#### STATE OF CONNECTICUT CONNECTICUT SITING COUNCIL

PETITION NO. 1315 A PETITION OF CELLCO PARTNERSHIP

FACILITY AT 7 COLBURN ROAD,

### RESPONSES OF CELLCO PARTNERSHIP D/B/A VERIZON WIRELESS TO CONNECTICUT SITING COUNCIL INTERROGATORIES

TITLE SHEET & INDEX

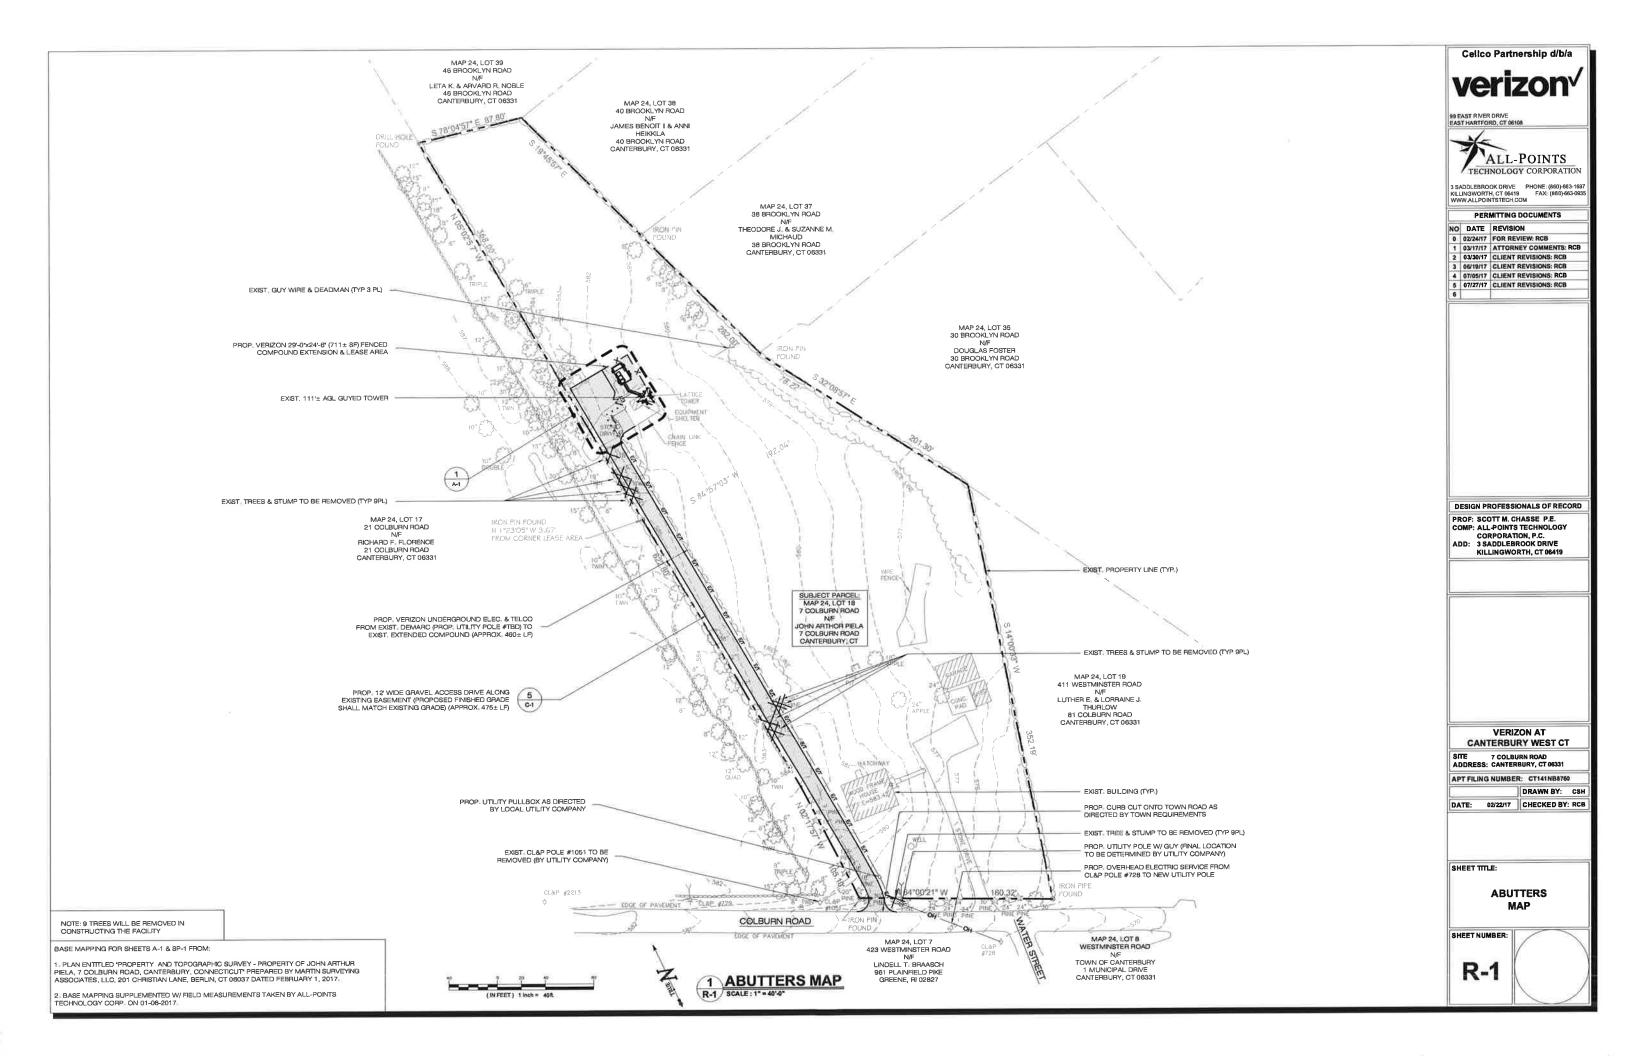
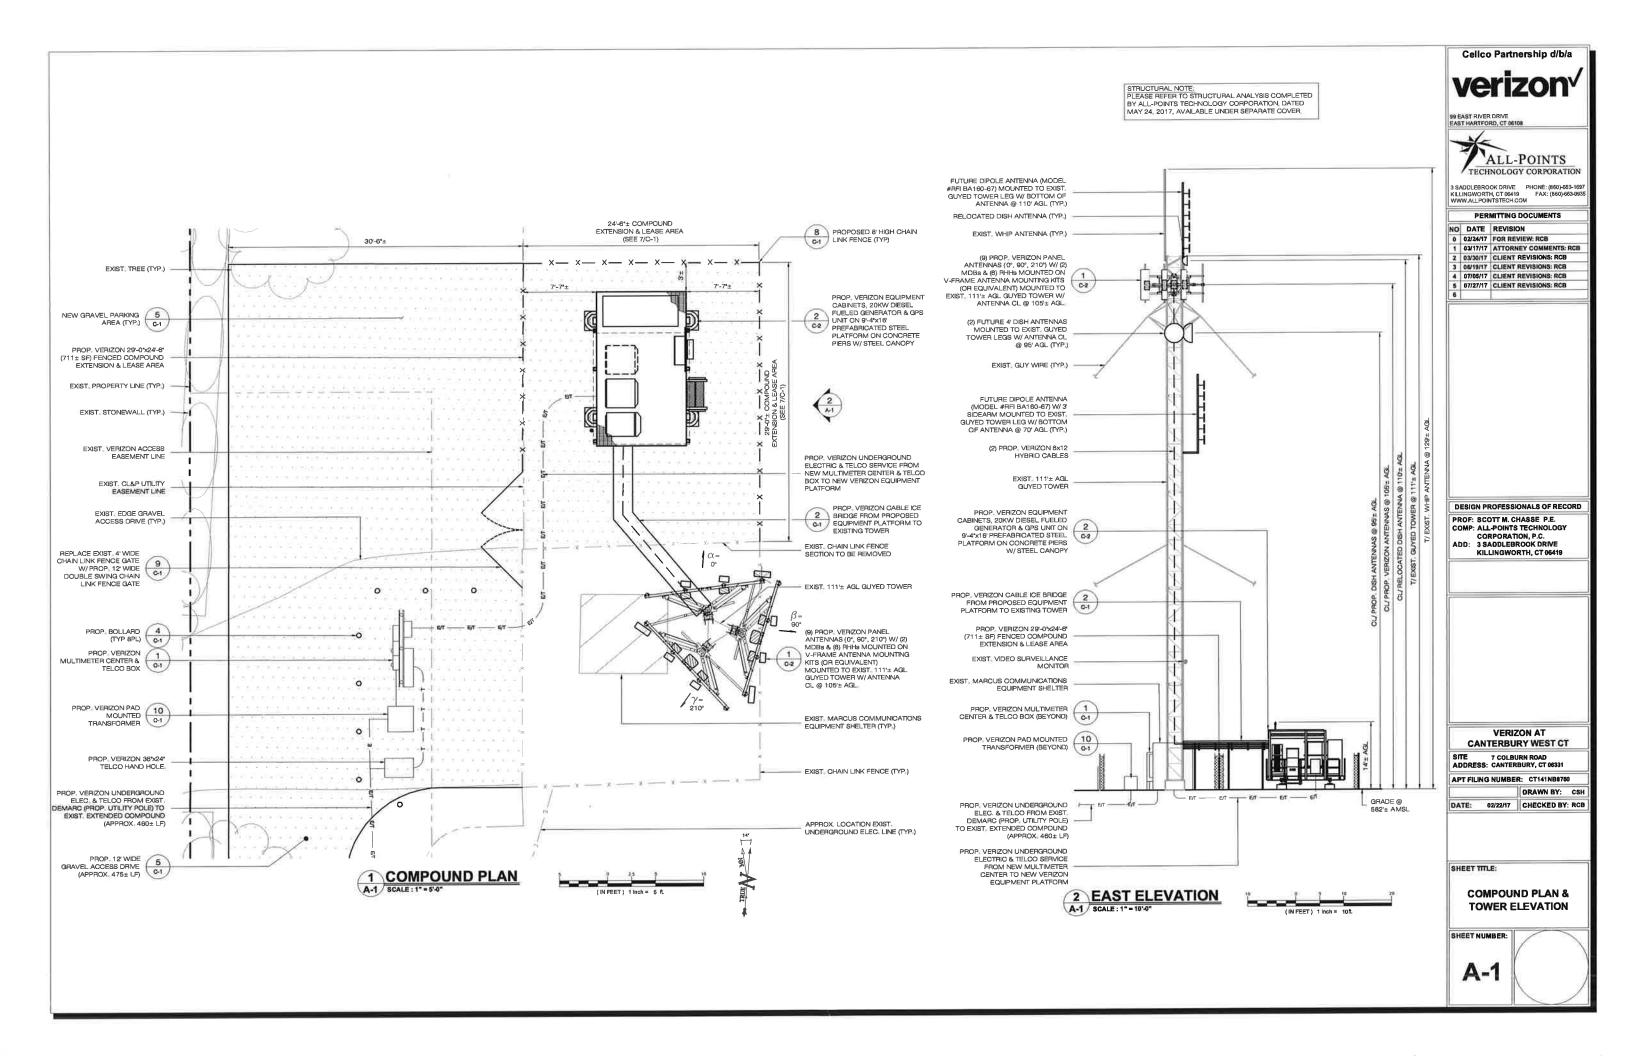
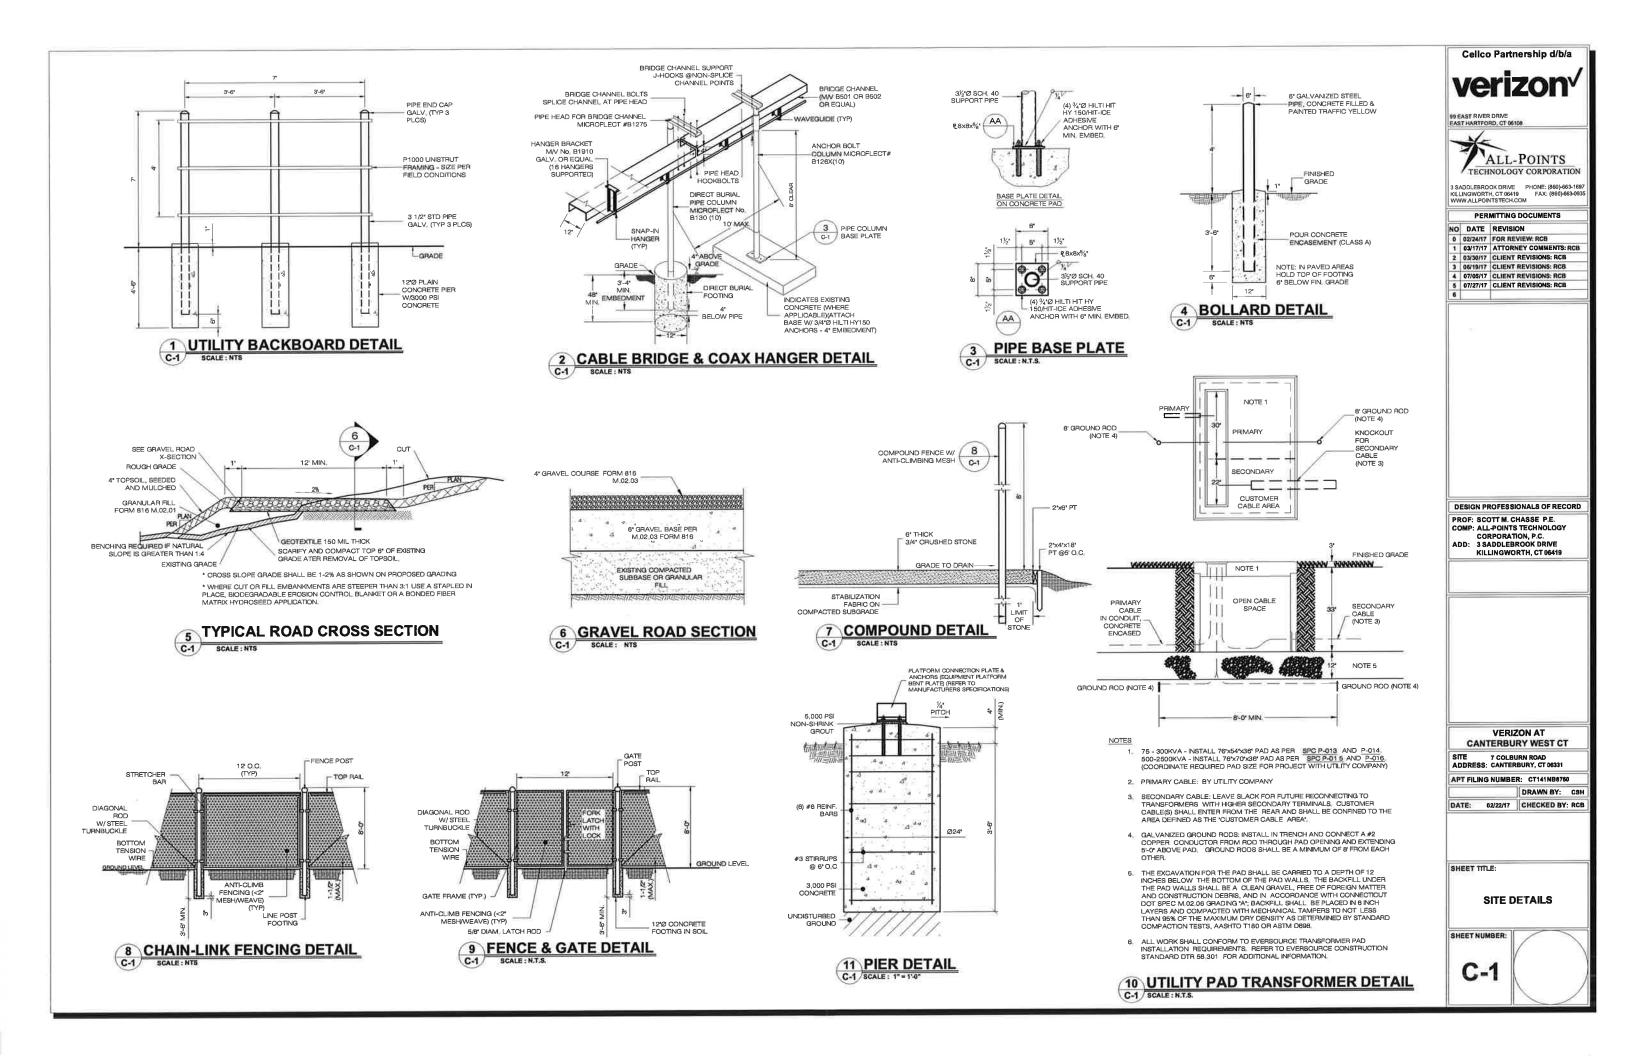
What types of vegetation would be removed to accommodate the new access road? If trees need to be removed, provide a tree count.

Are drainage controls necessary for the new access road? If so, provide detail.

Existing grass, brush and 9 trees, greater than 6" diameter at breast height, will need to be removed to construct the new gravel driveway and underground utility service from Colburn Road to the cell site. (See Updated Project Plans included in <u>Attachment 1</u>).

No formal drainage controls are needed or proposed for the new access driveway. The proposed driveway will maintain a gravel surface and will be constructed at existing grade. The same overland stormwater sheet flow will be maintained after construction of the new driveway is completed.
